Campaign Service BULLETIN

BULLETIN NUMBER:
CB17-J-001

STOPPER BRACKET INSTALLATION – 17V-324
(Transport Canada – 2017-265)

Figure 1 – Tighten Accelerator Pedal

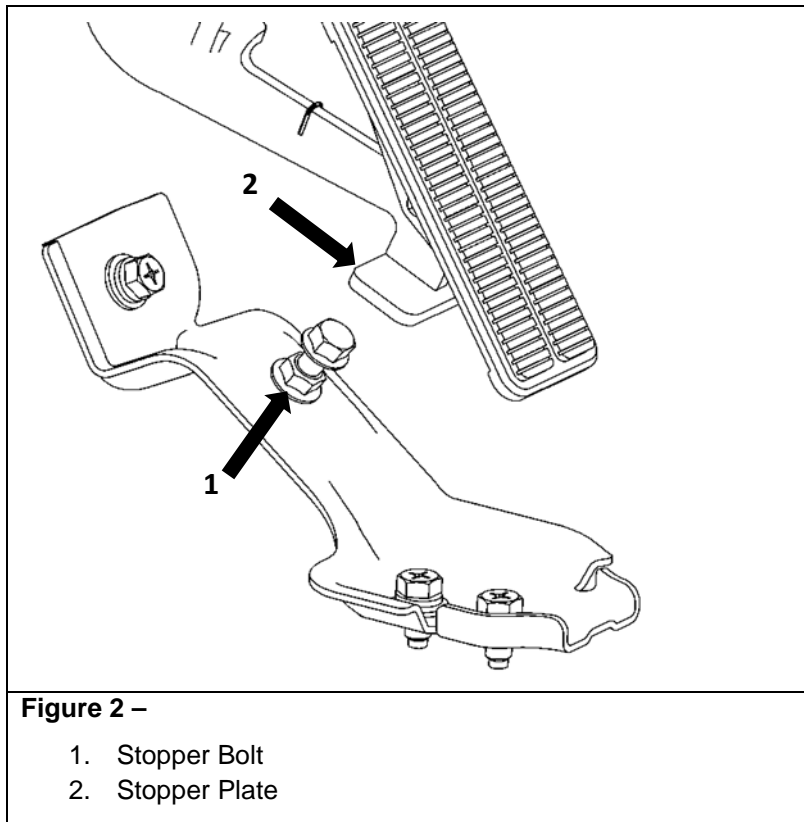
1. Set the parking brake, remove the key from the ignition and block the front wheels in a well-lit area.
2. Tighten the two (2) accelerator pedal mounting nuts (see Figure 1) to 18 Nm (13 ft. lb.).

Figure 3 – Temporary Bracket Installation

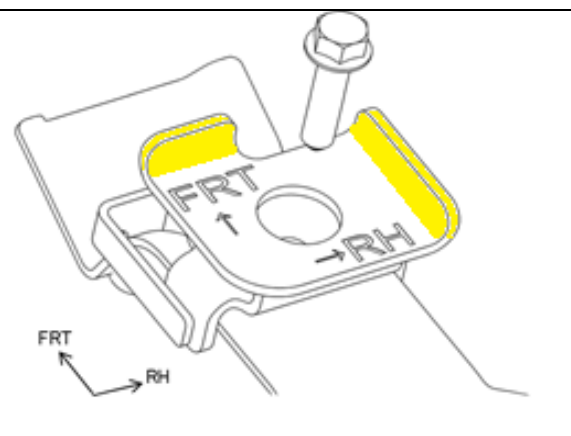
4. Temporarily install and hand tighten the new stopper bracket using the new bolt provided (see Figure 3). When tightened (even by hand), the head of the new mounting bolt should be below the flat surface of the new stopper bracket. Be sure the stopper bracket is aligned properly (see Figure 4).

Figure 5 – View From Right Side

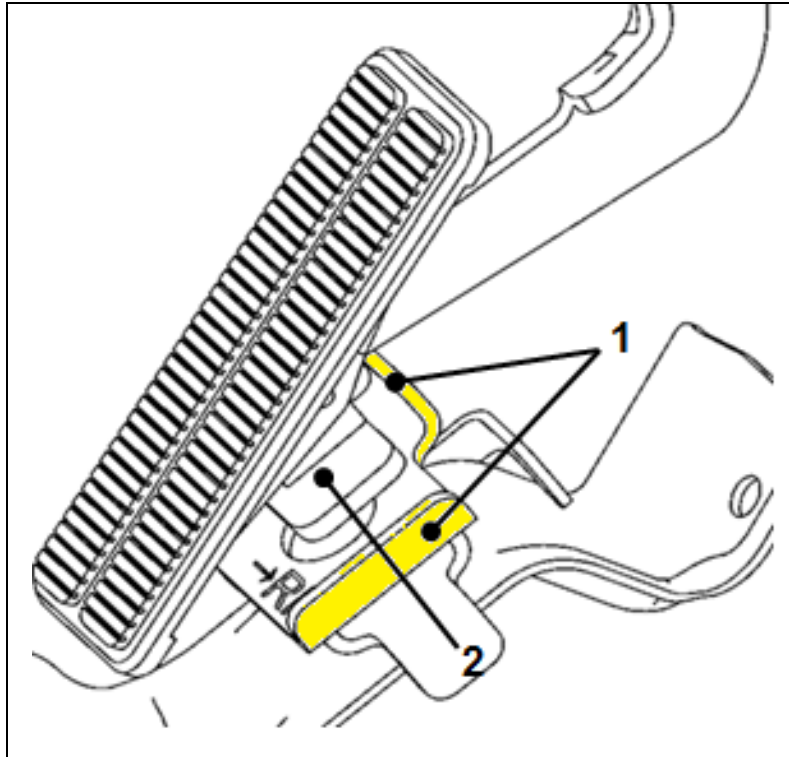
5. Depress the accelerator and ensure the stopper plate does not hit the flanged area of the stopper bracket (see Figures 5 and 6).

Figure 7 – View From Left Side

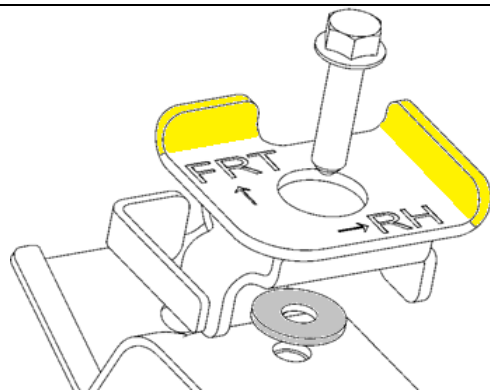
- a. If the stopper plate contacts the stopper bracket, torque the mounting bolt to **22Nm (16 ft. lb.) and go to Step 7.**
 - b. If the stopper plate does not contact the stopper bracket, check the clearance by depressing the pedal to WOT and attempting to insert one of the washers provided with the stopper bracket between the stopper plate and the stopper bracket (see Figure 7).

- i. If the washer does not fit between these two parts, the clearance between the stopper plate and stopper bracket is less than 2mm and no adjustment is necessary. Torque the mounting bolt to **22Nm (16 ft. lb.) and go to Step 7.**

Figure 9 – Scan Tool Check

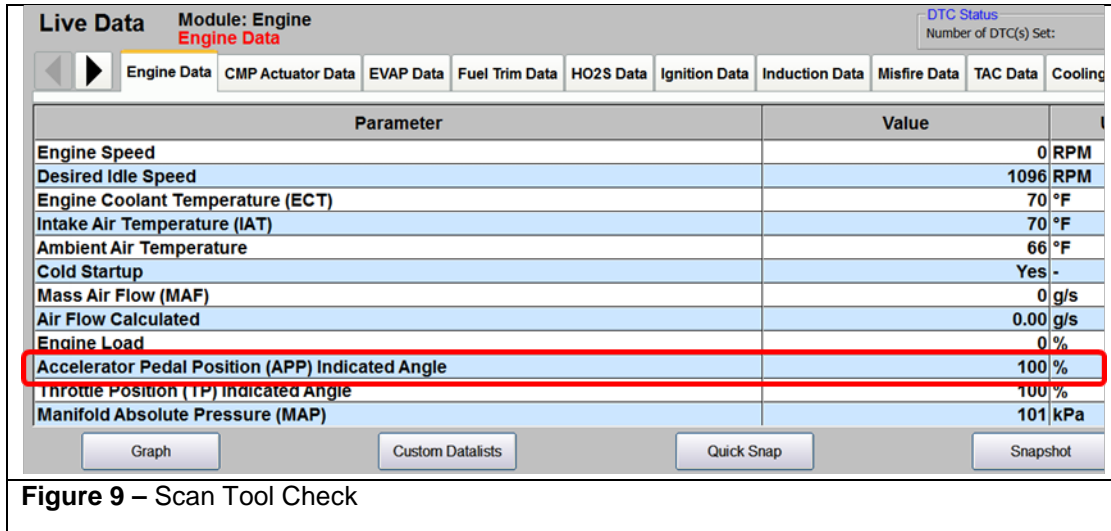
7. Connect IDSS, turn the key ON/engine OFF, and navigate to the engine control module data list to confirm “Accelerator Pedal Position (APP) Indicated Angle” parameter is at 100% during WOT (see Figure 9).
 - a. If the parameter is at 100%, continue to Step 8.
 - b. If the parameter is not at 100%, repeat Step 6 and recheck with IDSS. If the parameter continues to not be at 100%, and there is proper contact between the accelerator pedal and the stopper bracket, you may have incorrectly installed
